Revised pivot bolt for 9t INTRA axles

Important Information 117 Update – Technology

Former single parts:

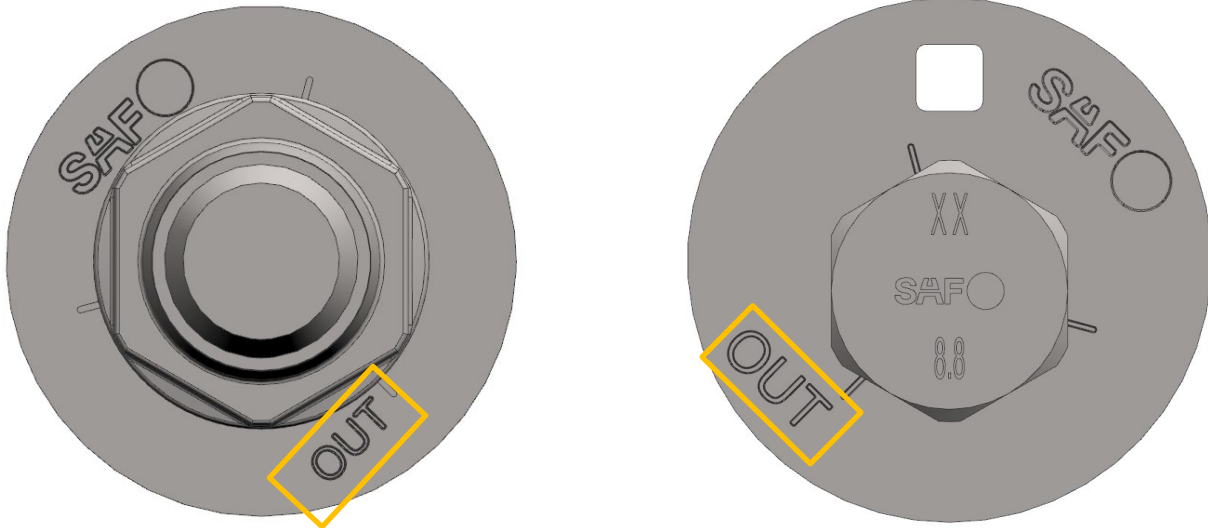
As part of the continuous further development of our products, the bolting of the INTRA axle to the hanger bracket / cross member has been revised. The new version is used for all 9t INTRA suspensions, regardless of whether a rigid or steering axle, disc or drum brake. The bolting of the MODUL axles and the tightening procedure for the 9t INTRA suspensions remain unchanged.

The new version of the pivot bolt replaces the previous bolting kits:

04 331 5029 01	WEAR PAD 170/60,5X4,75	
01 123 0001 01	ECCENTRIC WASHER D102 X 20	
01 101 2001 00	THRUST WASHER D88/30,5 X 20	
04 343 1048 88	HEX-SCREW M30X205 DIN933-8.8	
04 247 4022 80	LOCK NUT M30 Similar DIN985-8

03 143 1018 00 Pivot bolt - ADJUSTABLE

04 331 5029 01	WEAR PAD 170/60,5X4,75	
01 123 0006 00	ECCENTRIC WASHER D102 X 12	
01 101 2013 00	THRUST WASHER D79/30,5 X 12	
04 343 1087 88	HEX-SCREW M30X189 DIN EN ISO 4017	
04 247 4022 80	LOCK NUT M30 Similar DIN985-8

Please note that the thrust and eccentric washer must always be installed so that the "OUT" lettering is visible.
